Subject: **Request for Modification to the Individual Section 404 Permit, Section 401 Water Quality Certification and Neuse Riparian Buffer Authorization** for the construction of the US 70 Bypass from east of SR 1556 (Wayne Memorial Drive) to east of SR 1323 (Promise Land Road) in Wayne and Lenoir Counties. State Project No. 34461.3.8. TIP No. R-2554BB&C.

The North Carolina Department of Transportation (NCDOT) requests a modification to the existing Individual Section 404 Permit, Section 401 Water Quality Certification and Neuse Riparian Buffer Authorization for the R-2554 BB and C project. This modification is being requested due to clarifications or revisions needed on the previous modifications dated December 27, 2012 and January 29, 2013, a study area change between the planning phase and final design, and a topographic error on plan sheets 47 and 47A. Enclosed with this request are updated permit drawings, an updated impact summary sheet, and updated borrow site mapping.

**R-2554BB&C
WETLAND SITE MAP
REVISED: 05-17-2013**

SITE 12C

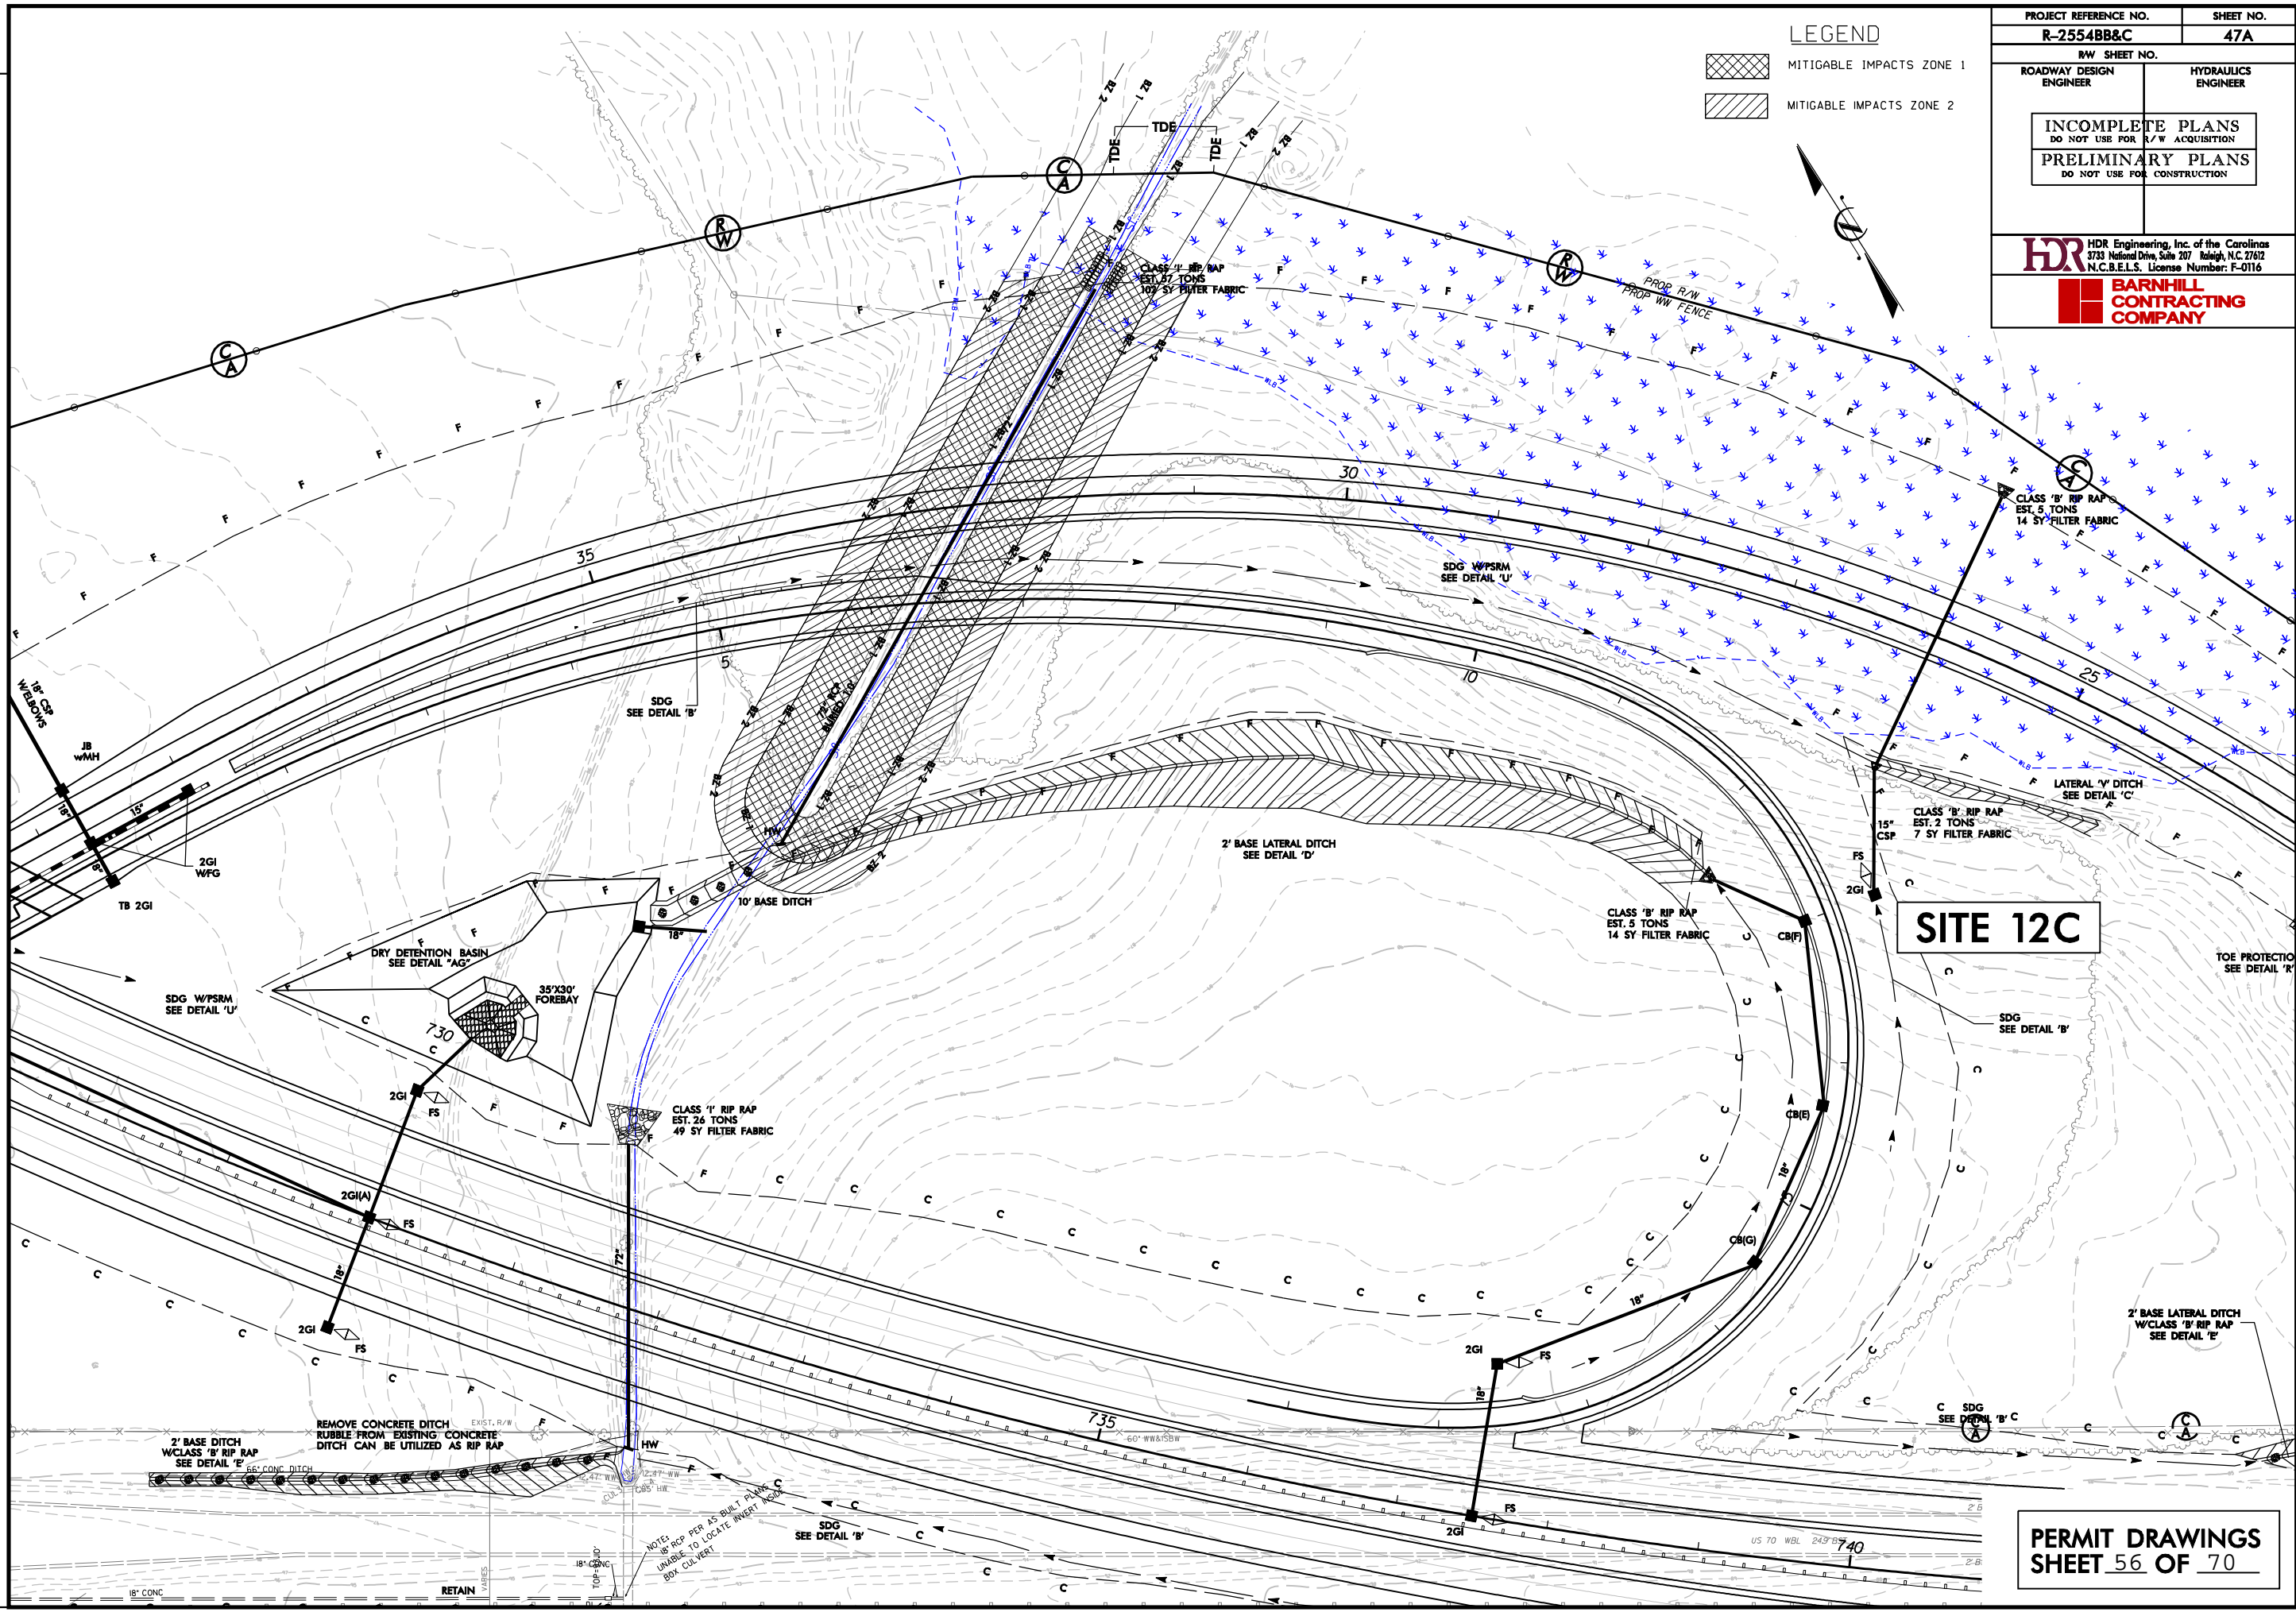
In addition to the study area change described above, a break in the topographic mapping caused an error on plan sheets 47 and 47A at Permit Site 12C. This was noticed while surveying the slope stake limits and the error results in the slope stake being approximately 12' beyond what was permitted. Permit Site 12C impacts will change slightly, adding 0.04 acre of additional fill while the amount of mechanized clearing remains unchanged.

PERMIT DRAWINGS
 SHEET 135A OF 135

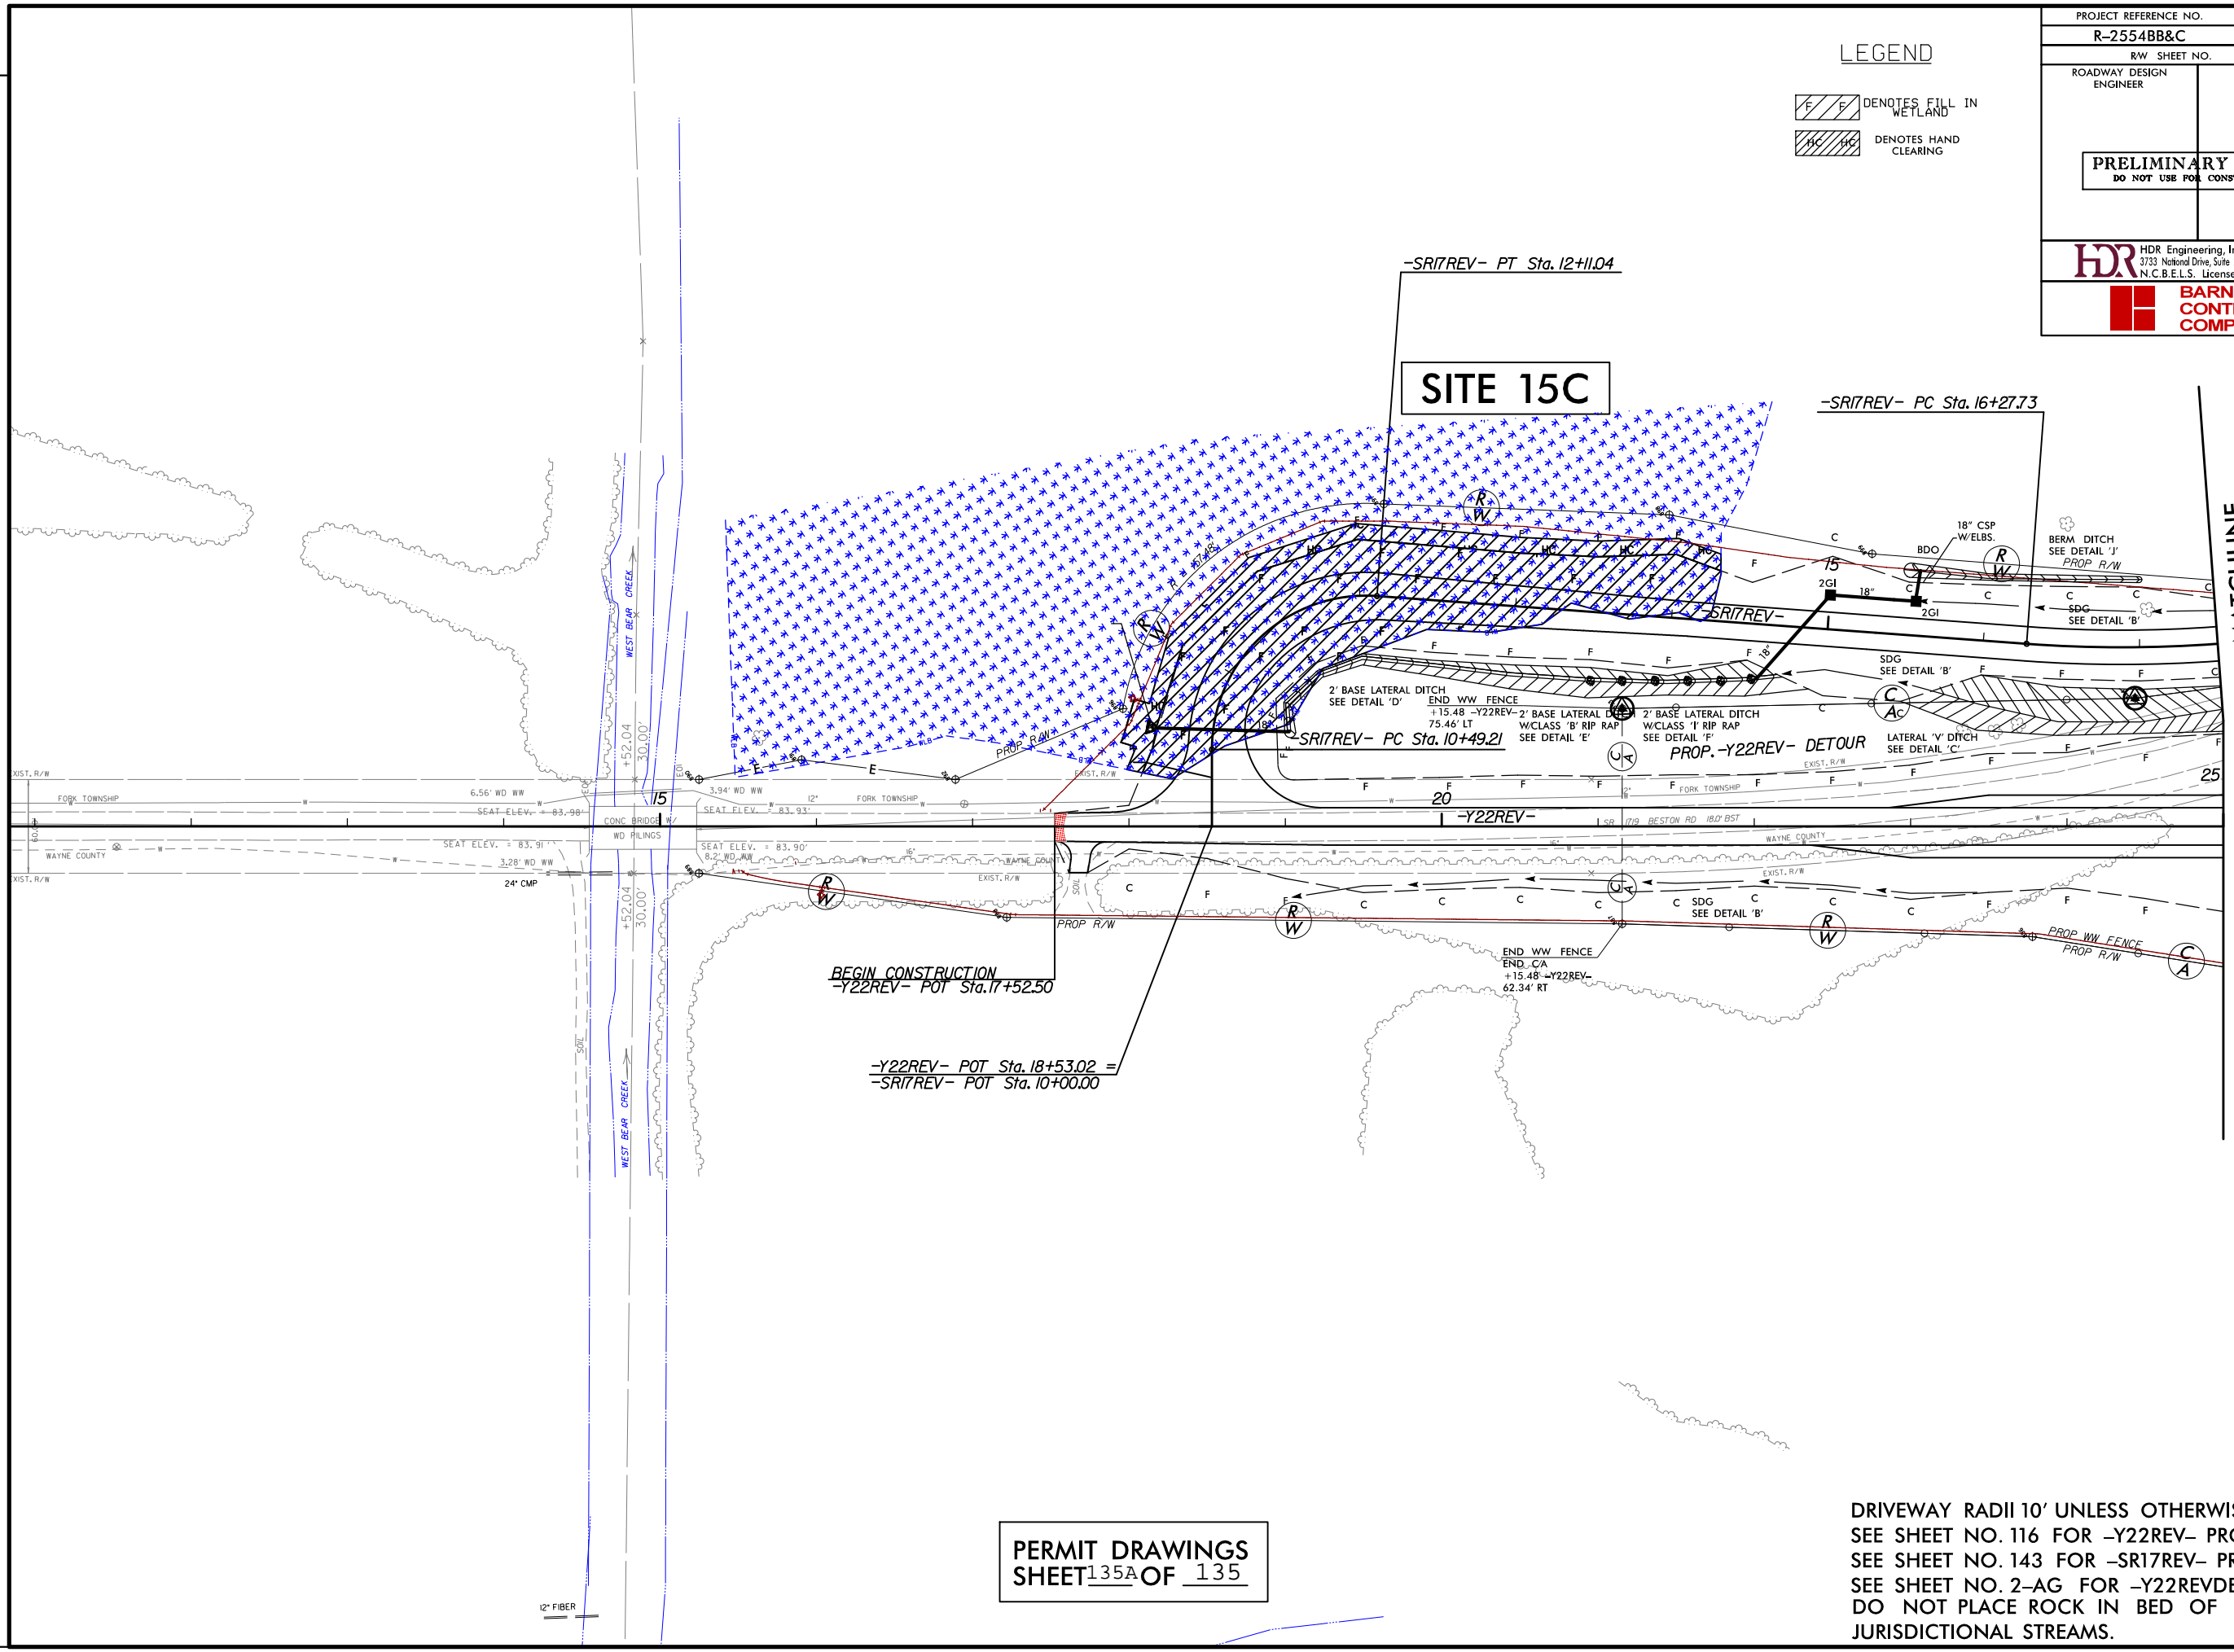
A jurisdictional wetland located at approximately Sta. 10+30 to 14+30 along SR17REV (Beston Road) was inadvertently omitted due to the change in study area. This area was not included in the Natural Resources Technical Report or wetland file initially used to create the plan sheets for the project as it was outside the study area. This wetland was discovered during permitted waterline relocations which are independent of the R-2554 project. The impacts for the service road which is within this additional study area, include 0.50 acre of fill in wetlands. Additionally there will be 0.11 acre of hand clearing in an area that was previously impacted by the utility relocations. This new area is being referred to on the permit drawings and summary impact table as Site 15C.
